E910-01-007  
March 19, 2001

Subject: Saxton Nuclear Experimental Corporation (SNEC)  
SNEC License Termination Plan (LTP), Response to NRC Request for  
Additional Information  
Operating License No. DPR-4  
Docket No. 50-146

**RESPONSE TO NRC REQUEST FOR ADDITIONAL INFORMATION  
GPU NUCLEAR - SAXTON NUCLEAR EXPERIMENTAL CORPORATION  
DOCKET No. 50-146, LICENSE No. DPR-4**

## HYDROGEOLOGIC CROSS SECTION A-A'

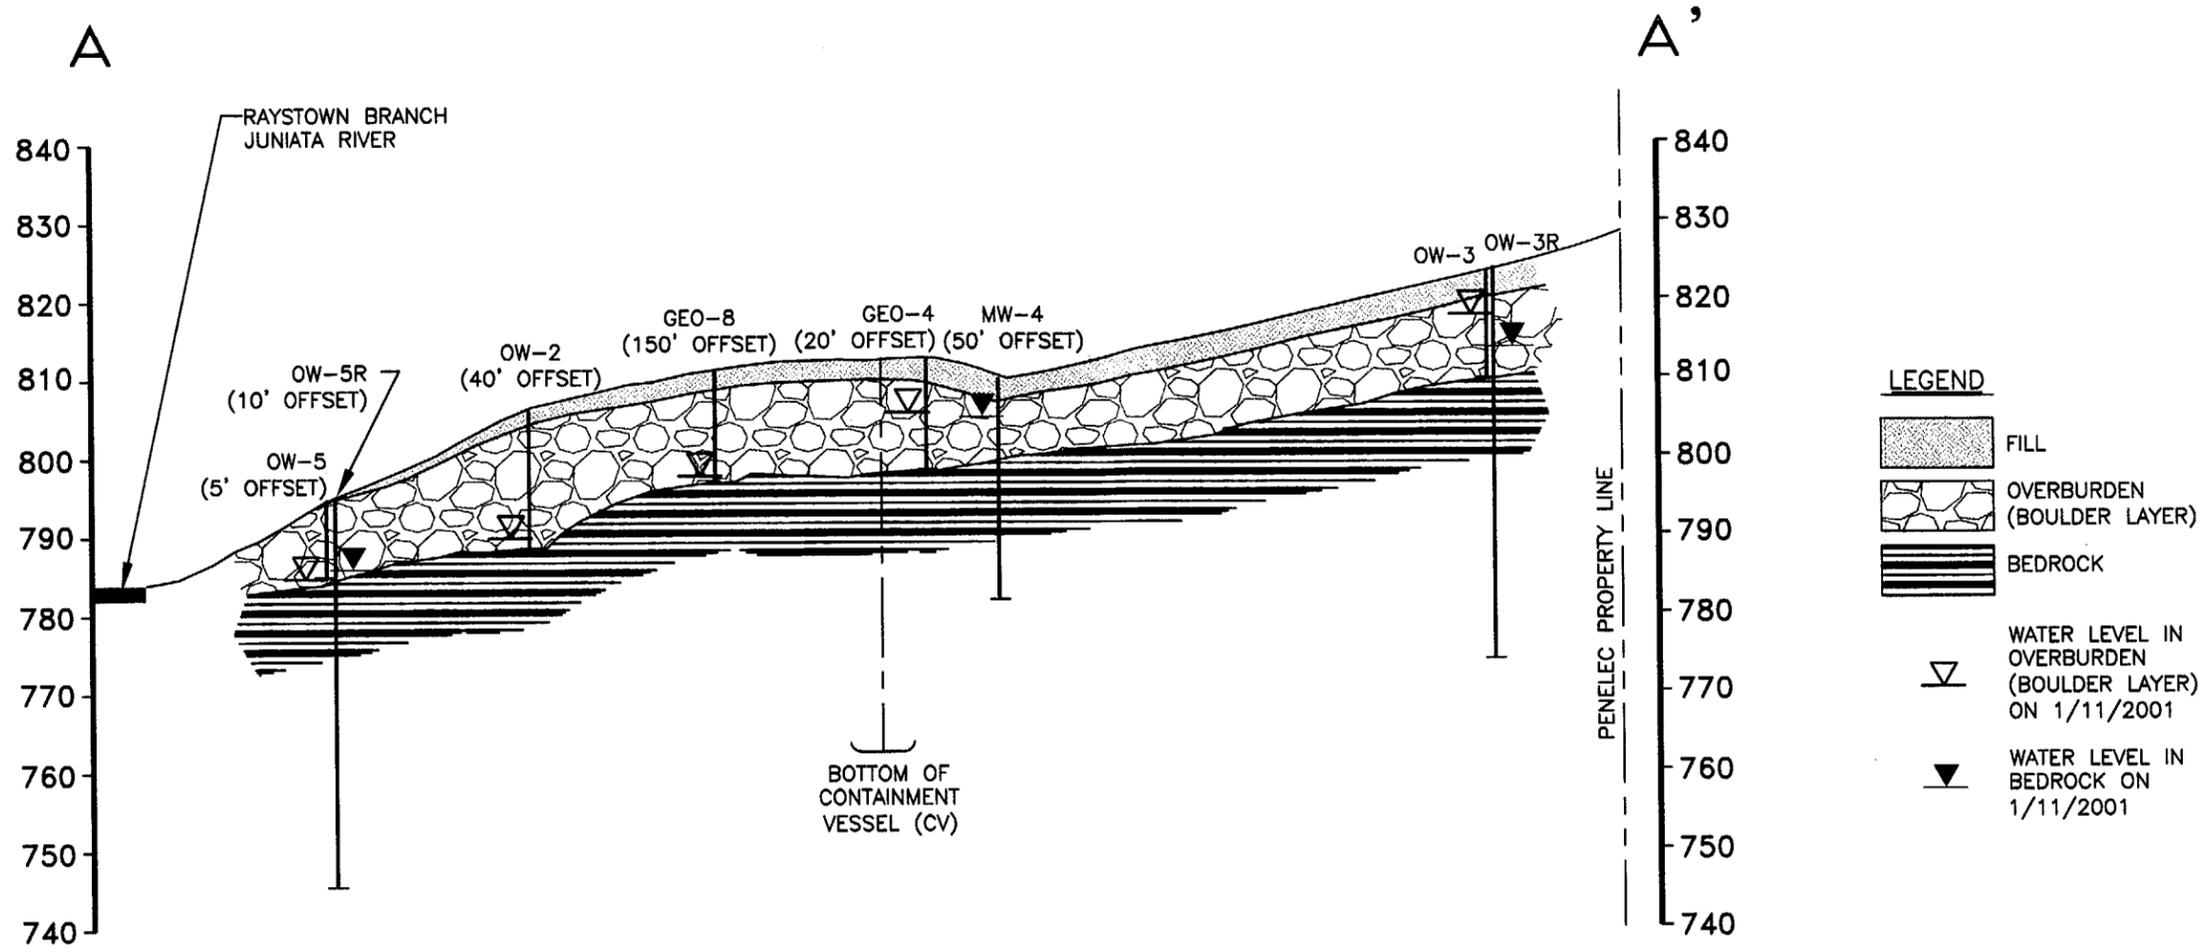
GPU Nuclear has addressed several issues pertaining to their justification that current monitoring wells are representative and appropriate for measuring potentially contaminated ground water onsite. However, the NRC staff believes that additional data still needs to be provided and that the data should address both potential onsite and offsite ground water contamination. For example, the following items should be determined and provided to the NRC: (1) current water level configuration maps representing the shallow water bearing unit (wells screened in the fill, boulder, and the upper weathered bedrock) and the bedrock water bearing unit (wells screened in the bedrock at a depth approximately equal to the base of the CV); (2) ground water flow patterns for both water units delineating discharge points; (3) ground water flow rates with and without dissolved radionuclides; (4) whether radionuclide contaminated ground water has either reached surface water discharge points or moved beyond the SNEC property; and (5) hydrogeologic cross sections delineating the lithology, and potentiometric surfaces across the site.

(5) Hydrogeologic cross sections delineating the lithology, and potentiometric surfaces across the site: see section 3.0 "GROUND WATER FLOW" and figures 2,4, 5, 7 and 8 of the Haley & Aldrich report.

- A thin layer of fill is present over the natural boulder layer throughout most of the area, although it may be thinner or absent near the surface water features.
- The elevation of the bedrock surface is generally decreasing from east to west (Figure 5). Also, Figure 6 suggests that the bedrock's elevation decreases north and south away from the area of the Containment Vessel (CV).

FIGURE 10

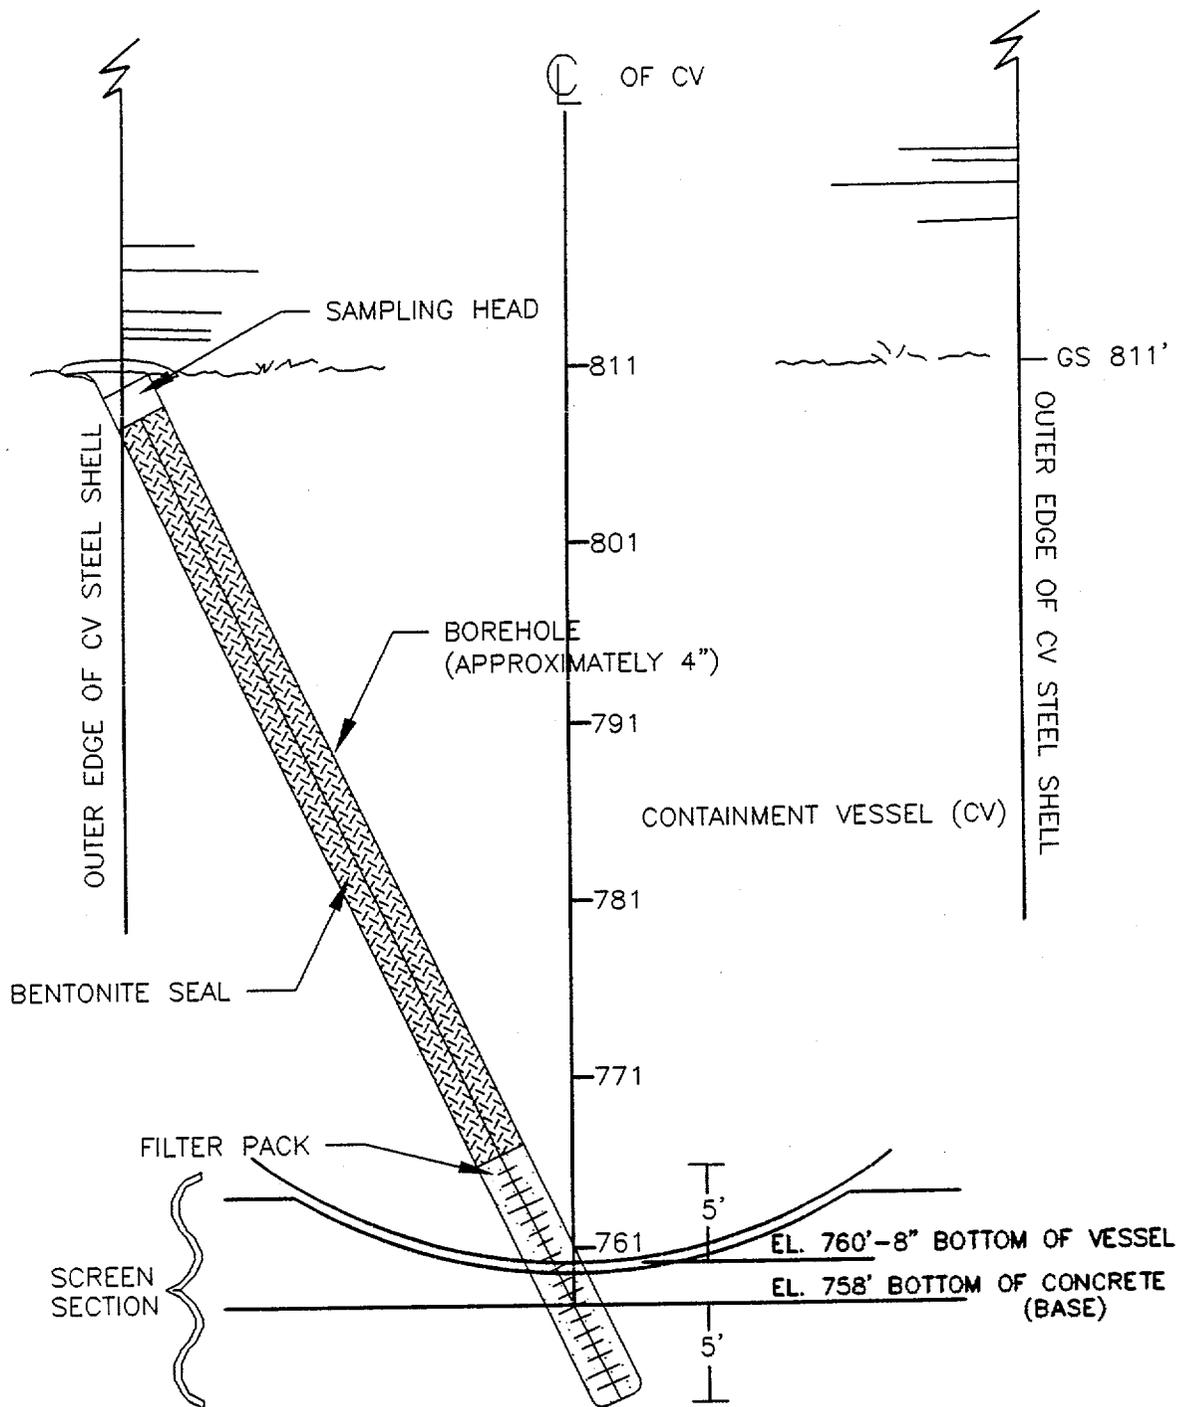
Based on the teleconference conducted on December 6, 2000, the NRC staff understands that GPU Nuclear proposes to install at least one bedrock monitoring well (during the spring or early summer 2001) hydraulically down gradient but adjacent to the CV. This monitoring well will be installed so that its screened interval will range from 5 feet above to 5 feet below the CV concrete base. GPU Nuclear intends to add this monitoring well to their modified schedule for sampling radionuclides and measuring water levels. Please confirm GPU Nuclear's proposed plan to add this monitoring well, as discussed on December 6, 2000, and provide this detailed plan to the NRC for review.

- Install this monitoring well approximately 15' hydraulically down gradient from the CV.
- Install monitoring well in a bedrock angle drillhole (25 degrees). The screen section should effectively extend five feet above the bottom of the CV shell and five feet below the concrete base see Figure 10 (attached).

- A GEOMON groundwater-sampling device should be utilized since this device is currently in use on site and its smaller diameter provides more options for filter design. A general schematic of the GEOMON, showing the screen section in relation to the base of the concrete, is presented on Figure 10 (attached).
